Access Compliance Report

Public Rights-of-Way

(Curb Ramps)

Intersection ID: 20587	Main Street: COLONY_RD	Cross Street: FAIRVIEW_RD	Location: SW
ADA ID: 491E0CF3A27A	Ramp Type: Perp	Initial Pass/Fail: Fail	Overall Compliance: No
		Severity Score: 10

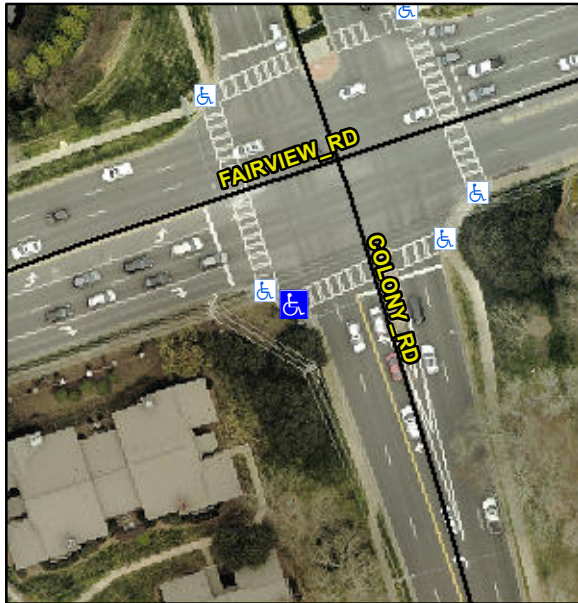
R304.5.1, R304.5.3

Compliance	Description	Data	Compliance	Description	Data
N/A	Ramp Length (in)	61.0	Yes	Ramp Slope (%)	5.6
No	Ramp Width (in)	43.0	No	Ramp XSlope (%)	3.4
N/A	Flare Type LT	N/A	N/A	Flare Type RT	N/A
N/A	Flare Slope LT (%)	N/A	N/A	Flare Slope RT (%)	N/A
N/A	Flare Traversable LT?	N/A	N/A	Flare Traversable RT?	N/A
N/A	Landing Length (in)	N/A	N/A	DWS Provided?	N/A
N/A	Landing Width (in)	N/A	N/A	DWS Contrast?	N/A
N/A	Landing Slope (%)	N/A	N/A	DWS Length (in)	N/A
N/A	Landing X Slope (%)	N/A	N/A	DWS Full Width?	N/A
N/A	Landing Curb? (Y/N)	N/A	N/A	DWS Offset (in)	N/A
N/A	Shared Landing?	N/A			
N/A	Gutter Ponding?	N/A	N/A	Gutter Slope (%)	N/A
N/A	Gutter Lip Ht (in)	N/A	N/A	Gutter X Slope (%)	N/A
N/A	Painted X Walk1?	Yes	N/A	Painted X Walk2?	N/A
	X Walk 1 Direction	To NE		X Walk 2 Direction	N/A
N/A	X Walk 1 Width (in)	110.0	N/A	X Walk 2 Width (in)	N/A
	X Walk 1 Slope (%)	2.8		X Walk 2 Slope (%)	N/A
	X Walk 1 X Slope (%)	1.0		X Walk 2 X Slope (%)	N/A

Remove & Replace Entire Ramp.
